**RE: Preliminary and Final Major Site Plan
Proposed Use: Industrial/Warehouse/Office
536-544 Washington Avenue
Block/Lot: 1502/12**

To: Township of Nutley Planning Board
From: Matthew Clark
Date: 05/13/2026
Subject: 536-544 Washington Avenue
(Site Plan Checklist Waiver Comments); Site Plan Application

DATE	REVISIONS
TITLE SHEET	
536-544 WASHINGTON AVENUE	
BLOCK 1502 - LOT 12 TOWNSHIP OF NUTLEY ESSEX COUNTY, NEW JERSEY	
MCB ENGINEERING ASSOCIATES, LLC	
P.O. BOX 588, 11 FURLER STREET TOWANA, NEW JERSEY 07511-0588 PHONE: (973) 812-6680 - FACSIMILE: (973) 812-6681 Certificate of Authorization No.: 24628108300	
scale AS NOTED	date 03/18/2026
project no. 4703	sheet no. 1 OF 10

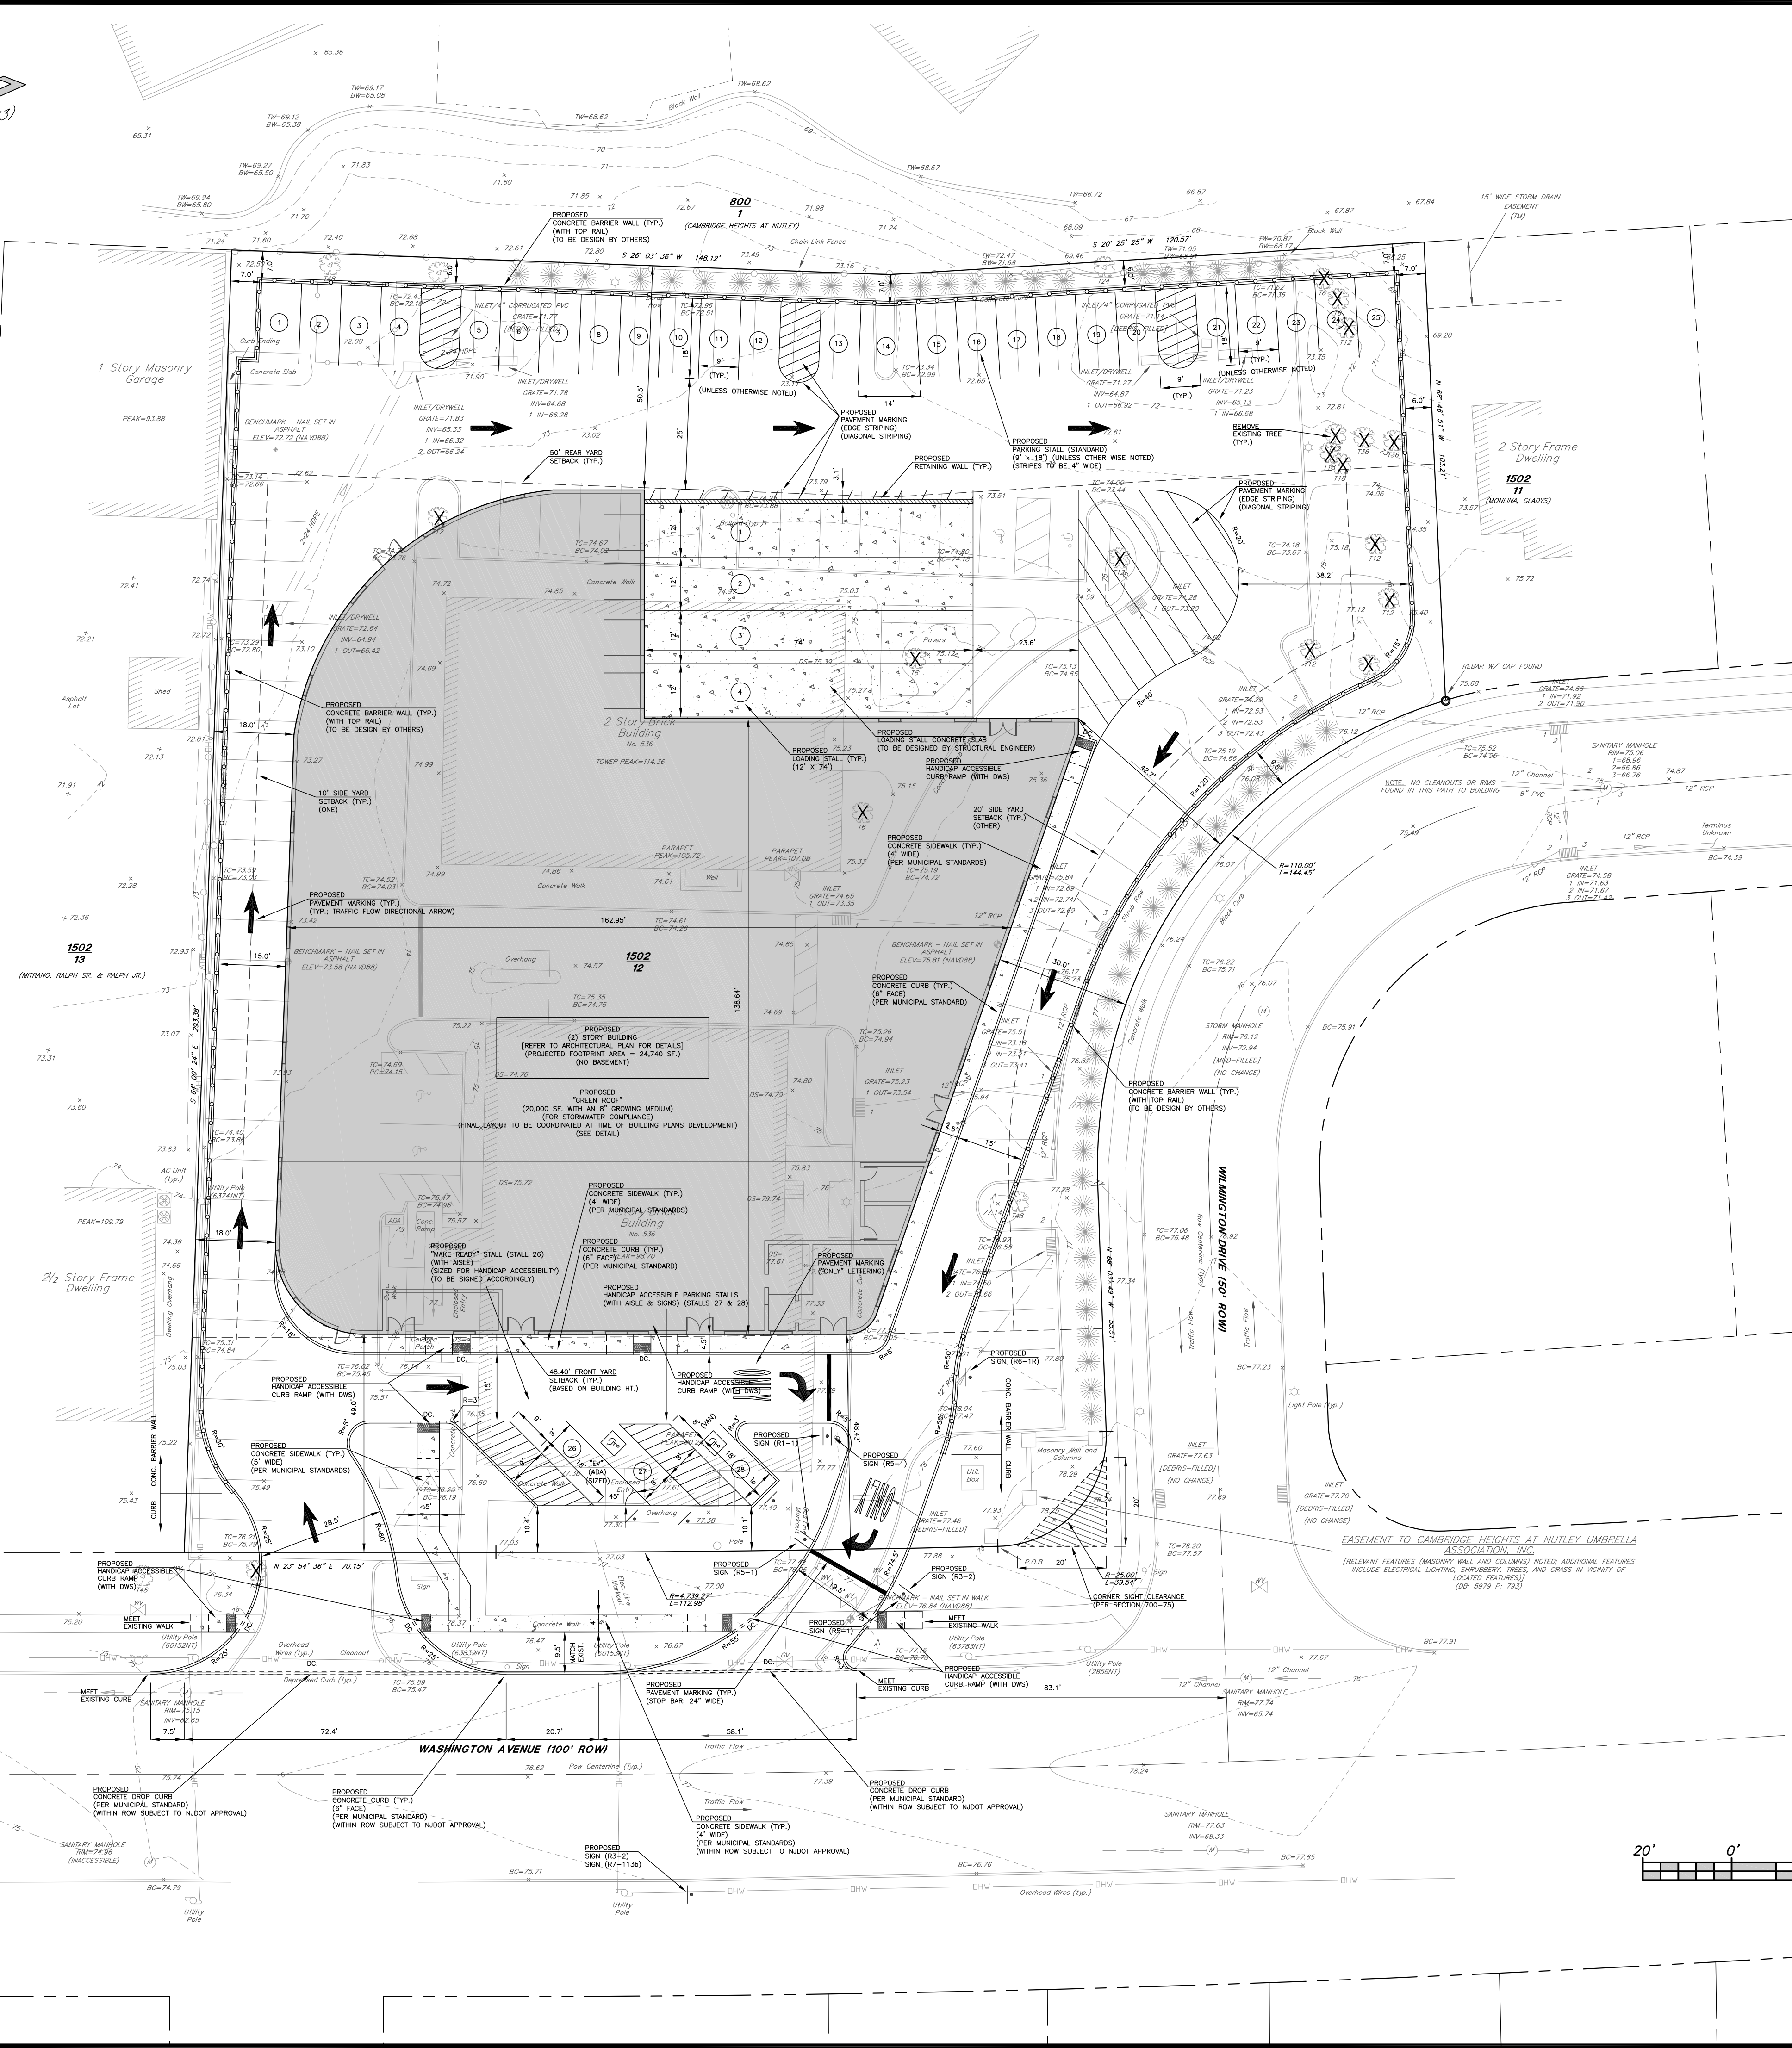
- 1) All disturbed areas within the Township's right-of-way shall be restored in accordance with Township Standards upon completion of utility installations; add a map note on Sheet 1 indicating this condition for construction.

- 4) Water and sanitary sewer service connection design and approvals shall be coordinated with Nutley DPW. The applicant shall arrange for pressure and flow tests with the department prior to final design and construction of the water system connections; add a map note on Sheet 1 indicating this condition for construction.

- 5) The applicant shall specify the size and location of the water meter as well backflow devices in accordance with §685-10. The applicant shall be responsible for obtaining and installing the water meter. The applicant shall coordinate with DPW for installation and location of the water meter and backflow devices. Add a map note on Sheet 1 indicating this requirement.

- 2) **Nutley Department of Public Works** - The Applicant is required to comply with all DPW requirements pertaining to sewer, water and storm sewer. Add a map note on Drawing 1 that this approval is required and will be provided post planning board approval and prior to map signature.

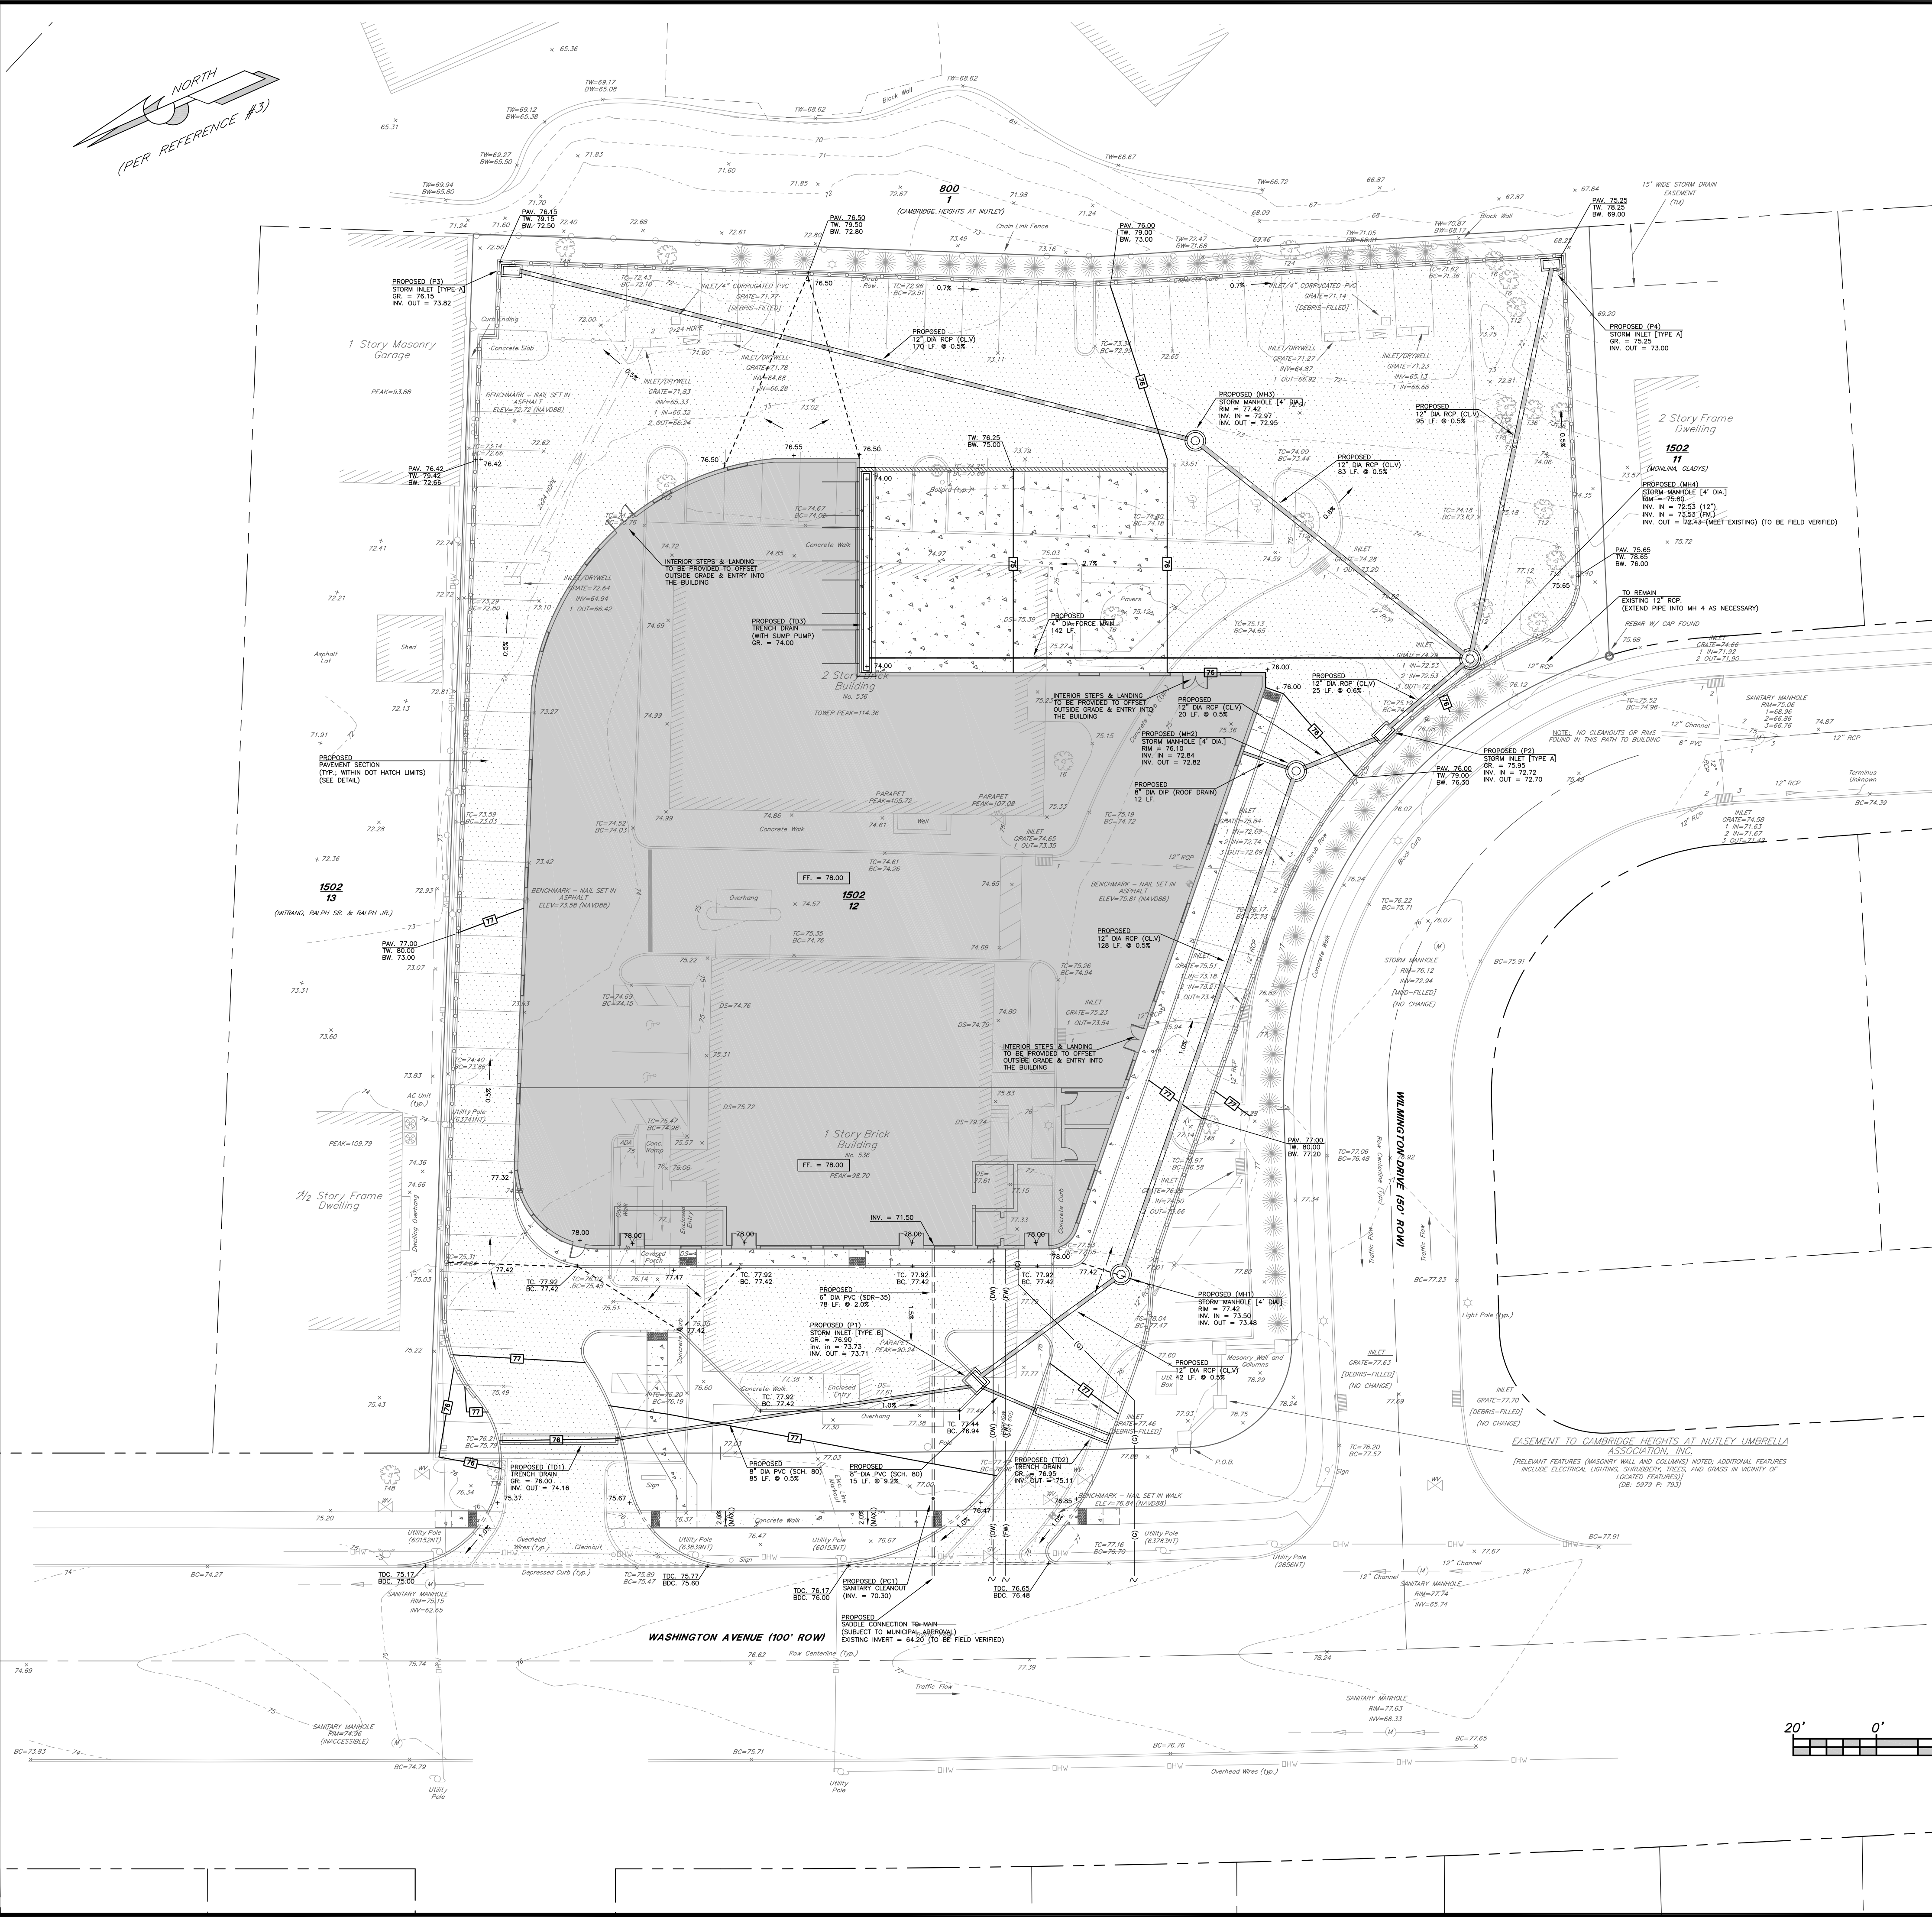
4. The Site Plan, sheet 2 of 10 of the site plan set shows the off-street parking computations based on 5,354 square feet of office space at 1 parking space per 300 square feet or 18 parking spaces, and 1 parking space per 3,000 square feet for the 24,740 square feet of warehouse space or 9 parking spaces for a total of 27 parking spaces required. However, the computations show a total of 10 employees or 3 parking spaces required. The Applicant shall provide testimony regarding the actual occupancy of the proposed office and warehouse, including any expectations for visitors. If not all the 26 parking spaces along the rear property line are not required by the end user, then some of those parking spaces should be “banked” and replaced with pervious surface.

SITE PLAN COMMENTS (SHEET 2)

- 1) The applicant shall provide both the existing conditions and proposed conditions zoning information on the Zoning Schedule of Regulations on Sheet 2.

- 9) A retaining wall is proposed around the perimeter of the parking area with a note "proposed concrete barrier wall to be design by others". Full design and calculations for the wall shall be provided prior to a building permit is issued. The Site Plans contain a Concrete Barrier Wall Section Detail on Sheet 7 that shows a top rail on top of the poured in place concrete wall. The Site Plan shall clarify the construction detail to show the fence rail material and height and how it will be embedded in the wall.
